IEC 62477-1
Edition 2.0 2022-05

**SAFETY REQUIREMENTS FOR POWER
ELECTRONIC CONVERTER SYSTEMS AND
EQUIPMENT**

Part 1: General

CORRIGENDUM 1

Figure 5 – Time-voltage zones for accessible circuits of DVC As and DVC B – DC during single fault conditions

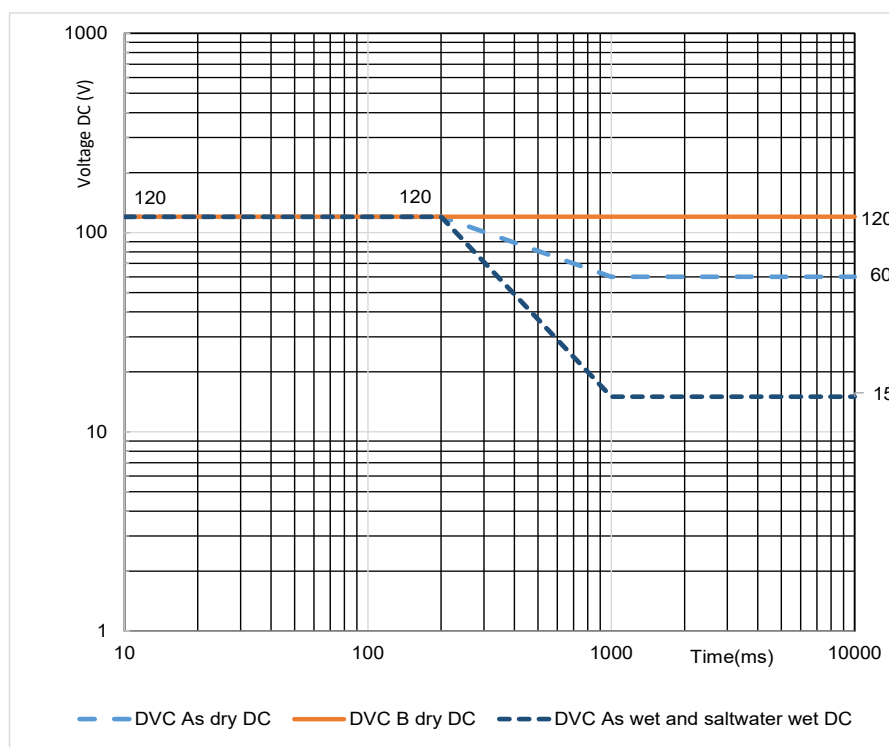
Replace Figure 5 with the following new figure:
